MGS Memos and DEP Permits

INTERDEPARTMENTAL MEMORANDUM

DATE: 6/19/15
TO: DAVID CHERRY, ENVIRONMENTAL SPECIALIST, DEP BUREAU OF LAND AND WATER QUALITY, DIVISION OF LAND RESOURCE REGULATION
CC: JOE LeBLANC, CONSULTANT; PETER A. SLOVINSKY, MGS; DENIS-MARC NAULT, DMR, BRAD ZITSKE AND JOHN PERRY, IF&W
FROM: STEPHEN M. DICKSON, PH.D., MARINE GEOLOGIST
RE: NRPA REVIEW COMMENTS, L-26631-4D-A-N, KING BLUFF STABILIZATION, MILLER POINT, BRUNSWICK, MAINE

DATE: 9/9/16
TO: DAVID CHERRY, ENVIRONMENTAL SPECIALIST, DEP BUREAU OF LAND AND WATER QUALITY, DIVISION OF LAND RESOURCE REGULATION
CC: PETER A. SLOVINSKY, MGS
FROM: STEPHEN M. DICKSON, PH.D., MARINE GEOLOGIST *SMD*
RE: NRPA REVIEW COMMENTS, L-26631-4D-G-M, KING BLUFF STABILIZATION, MILLER POINT, BRUNSWICK, MAINE

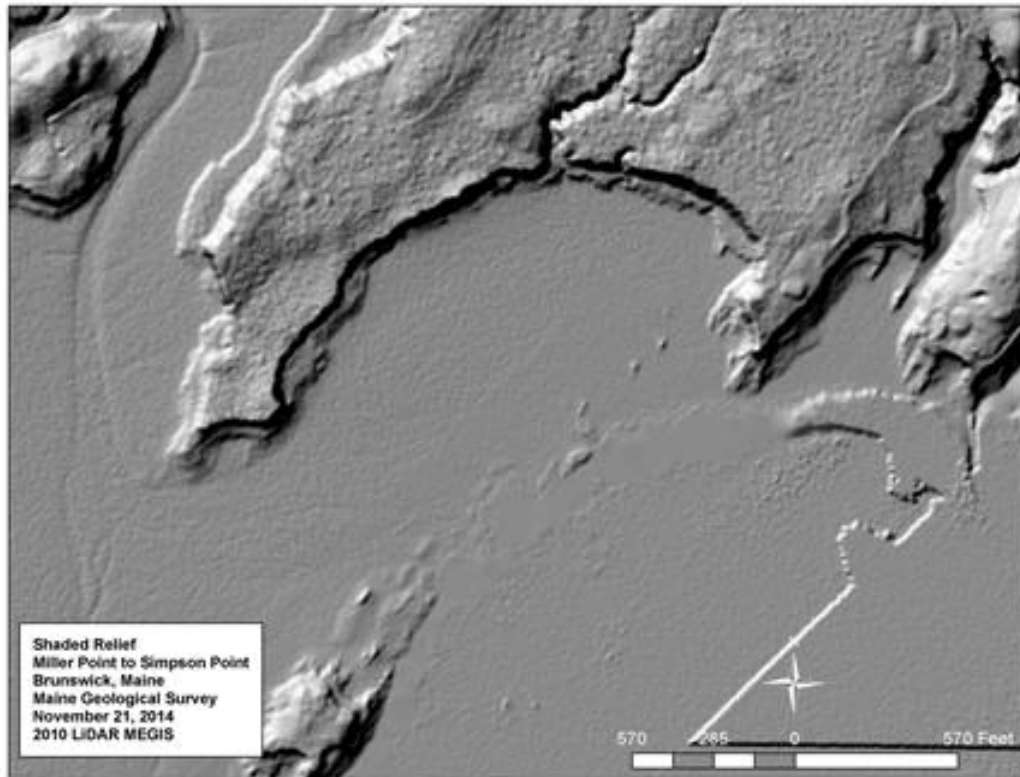
This design, to the maximum extent practicable, mimics the transfer of soil from land to the sea over what we estimate to be the next one to two decades. Without any shoreline stabilization, natural slope failures at this site will result in the injection of large volumes of muddy sediment (the Presumpscot Formation; Weddle, 2000) into the upper intertidal zone. This sediment is often colonized by salt marsh vegetation resulting in a fringing marsh at the toe of the coastal bluff that helps protect the bluff from further erosion (Figure 3; Kelley *et al.*, 1988).

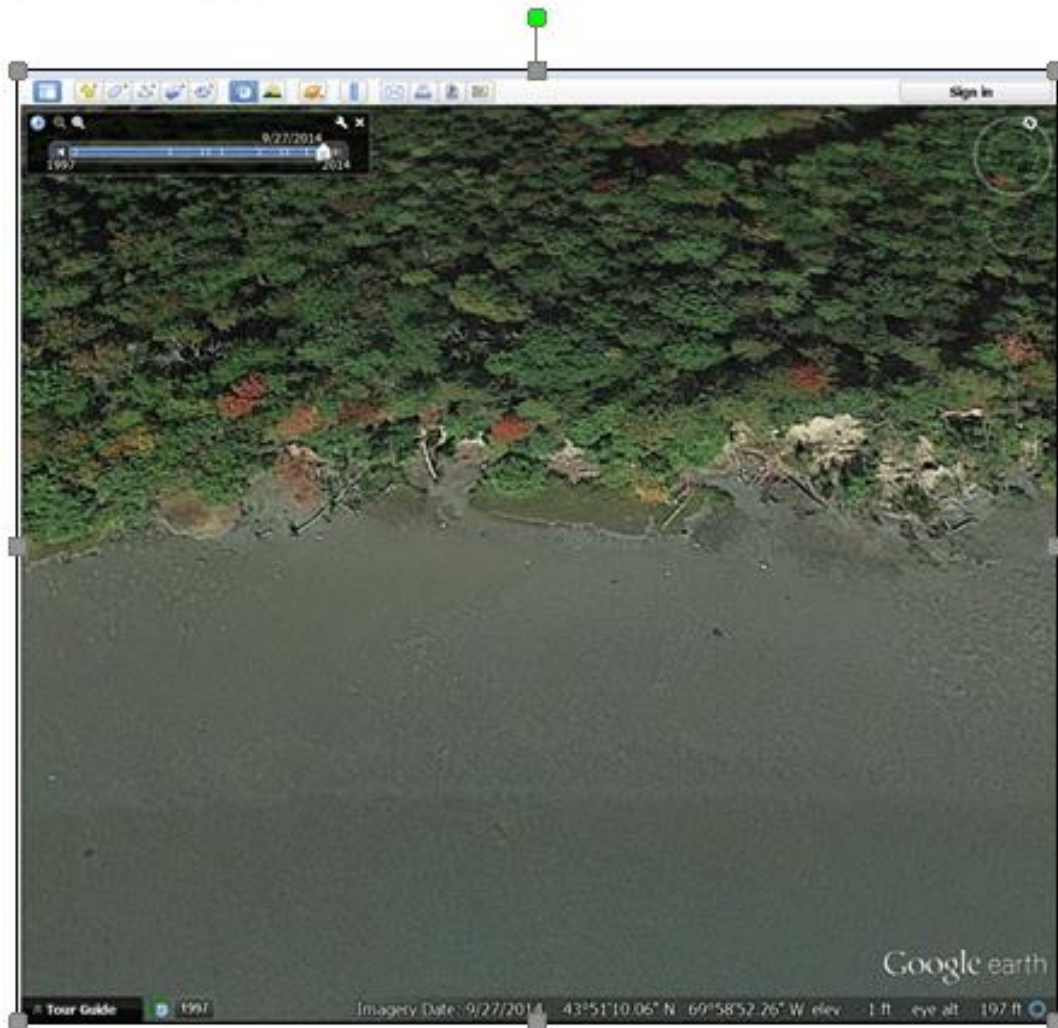
Along the shore of Miller Point in Middle Bay, there are patches of fringing salt marsh. The fringing marsh is visible in air photographs (Figure 2), topographic relief (Figure 4) and has been mapped (Timson, 1976). These marshes, along with the one proposed for construction in this

Figure 5. A shore-perpendicular transect 500 yards long is illustrated with the yellow line used to estimate an intertidal sediment budget. For reference, Bunganuc Rock is visible about 200 yards south of the end of the yellow line.

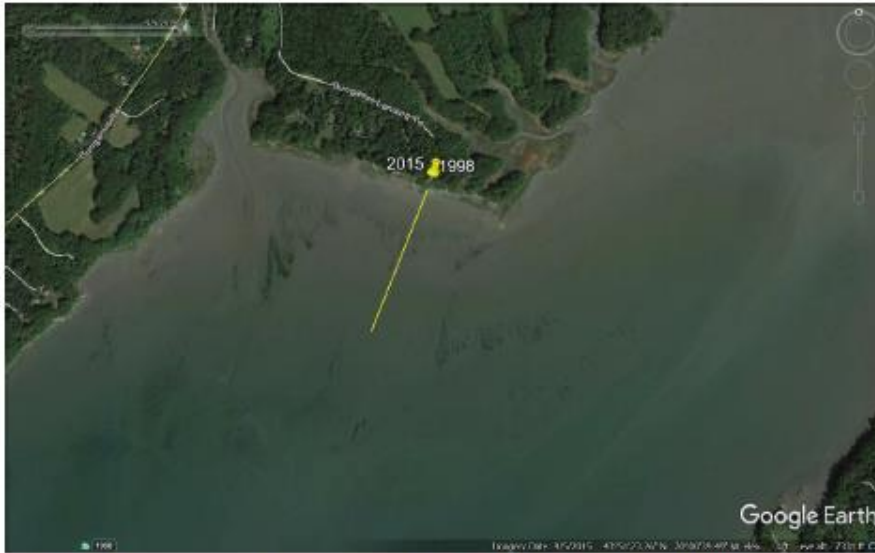
In order to estimate the impact to the intertidal zone, the area of the intertidal surface seaward of the property must be calculated. A simple 350 feet (117 yards) of frontage at the high tide line was used for the shore-parallel length of the intertidal zone. The distance offshore of the intertidal zone was estimated to be on the order of 500 yards using Nautical Chart 13290, the relative position of Bunganuc Rock, and Google Earth (Figure 5). The intertidal area by this estimate is 58,500 square yards.
